Access Compliance Report

Public Rights-of-Way

(Curb Ramps)

Intersection ID: 16470	Main Street: E_INDEPENDENCE_BV	Cross Street: FARMINGDALE DR	Location: SW
ADA ID: 4F06F4B62EC9	Ramp Type: Perp	Initial Pass/Fail: Fail	Overall Compliance: No
Severity Score: 12.5			
Codes/Mitigation Info/Possible Solution		Field Measurements/Component Compliance

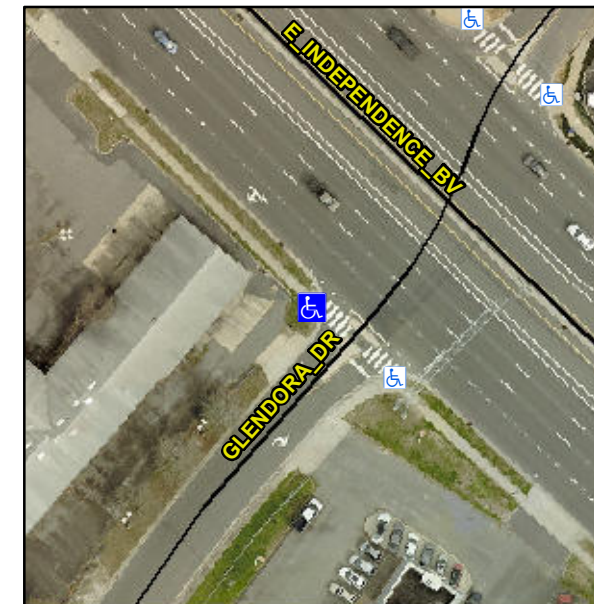
Not Found, R304.2.2

Compliance	Description	Data	Compliance	Description	Data
N/A	Ramp Length (in)	78.0	No	Ramp Slope (%)	8.7
Yes	Ramp Width (in)	58.0	Yes	Ramp XSlope (%)	0.4
N/A	Flare Type LT	N/A	N/A	Flare Type RT	N/A
N/A	Flare Slope LT (%)	N/A	N/A	Flare Slope RT (%)	N/A
N/A	Flare Traversable LT?	N/A	N/A	Flare Traversable RT?	N/A
N/A	Landing Length (in)	N/A	N/A	DWS Provided?	N/A
N/A	Landing Width (in)	N/A	N/A	DWS Contrast?	N/A
N/A	Landing Slope (%)	N/A	N/A	DWS Length (in)	N/A
N/A	Landing X Slope (%)	N/A	N/A	DWS Full Width?	N/A
N/A	Landing Curb? (Y/N)	N/A	N/A	DWS Offset (in)	N/A
N/A	Shared Landing?	N/A			
N/A	Gutter Ponding?	N/A	N/A	Gutter Slope (%)	N/A
N/A	Gutter Lip Ht (in)	N/A	N/A	Gutter X Slope (%)	N/A
N/A	Painted X Walk1?	Yes	N/A	Painted X Walk2?	N/A
	X Walk 1 Direction	To SE		X Walk 2 Direction	N/A
N/A	X Walk 1 Width (in)	121.0	N/A	X Walk 2 Width (in)	N/A
	X Walk 1 Slope (%)	2.9		X Walk 2 Slope (%)	N/A
	X Walk 1 X Slope (%)	1.3		X Walk 2 X Slope (%)	N/A

Remove & Replace Entire Ramp.
